## SAFETY INFORMATION BULLETIN 09/2022

**Bulletin number:** 09/2022

**Subject:** Tightening the bolts from the engine bed to the engine block

**Airplanes affected (s/n):** All types without engine bed ROTAX (Aircrafts with a only engine bed): JA-200 (Skyleader 200), JA-400 (Skyleader 400), JA-500 (Skyleader 500), JA-600 (Skyleader 600), GP One

1 - Engine 2 - 4pcs of Bolts 3 - Engine Bed

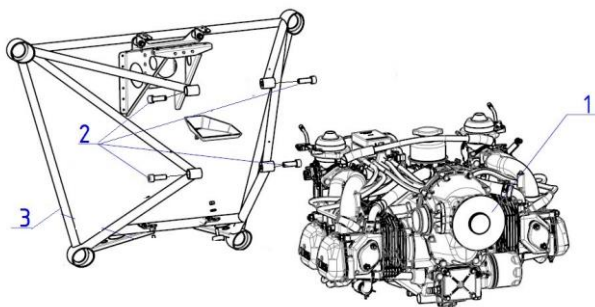
**Reason:** Preventing the possibility of in-flight release, as a result of vibrations and thermal shocks of the engine, the powder coating on the contact surfaces of the engine bed can be extorted. Despite the fact that the screw is sealed with thread glue, a small play may appear on the contact surface, which is undesirable.

**Action:** After the first 50 engine hours, it is necessary to check the tightening of the screws from the engine bed to the engine, tightening torque 50 Nm. Carry out other screw tightening checks at regular service intervals. If it happens that the screw is not tightened to the required torque, it is necessary to turn it, apply a new layer of thread adhesive Loctite 243 or equivalent and tighten with a torque of 50 Nm. During assembly, do not forget to return the Z-type disc spring under the screw head, if it is not damaged, in case it is necessary to replace it.
